**NTUA – TWIN LAKES WELL / NGWSP REACH 12A
CITY OF GALLUP
Gallup Joint Utilities**

AMENDMENT NO.: One (1)
PAGES: # (19)

FORMAL BID NO.: 1612

FLUSH TYPE FIRE HYDRANT DETAILS

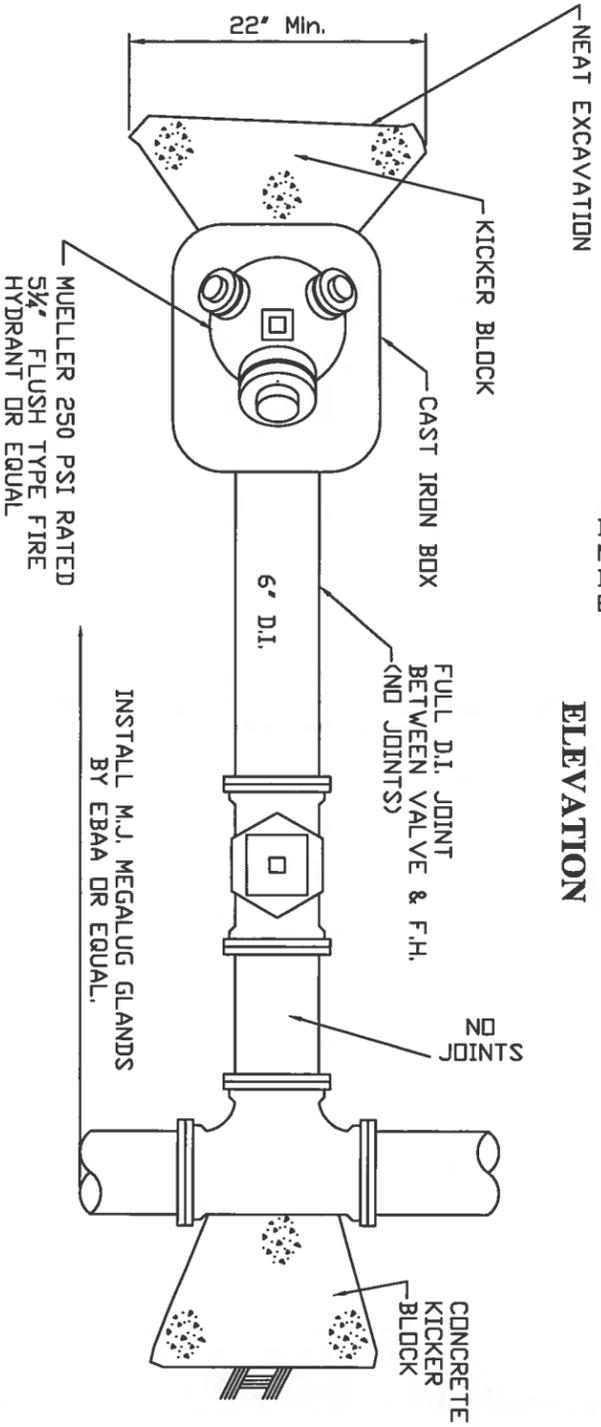
- The attached Flush Type Fire Hydrant Detail is hereby made part of the project drawings.

- Q:** *Please issue a copy of the Flush Type Fire Hydrant detail provided at the Pre-Bid viewing by Addendum so that it is part of the contract document and available to all bidders.*

This item of work is flush type fire hydrant assembly, Mueller A-415 5¼” flush type fire hydrant or equal as detailed including two (2) – 25’ hoses with 2½” N.S. threaded brass ends complete and in place. Fire hoses to be turned over to NTUA. Payment will be made at the **Contract Lump Sum Price Bid**:

- A:** The detail is include and has been made part or the contract documents.
- Q:** *Please provide photos of the interior of the well house including both the chlorination room and metering and control room.*

NOTE: CONTRACTOR TO PROVIDE HYDRANT BARREL HEIGHT AS REQ'D. FOR PROPER HEIGHT ABOVE FINISHED GRADE. FIRE HYDRANTS TO BE INSTALLED PLUMB AND IN AREAS TO CLEAR EXISTING OR ANY FUTURE SIDEWALKS.
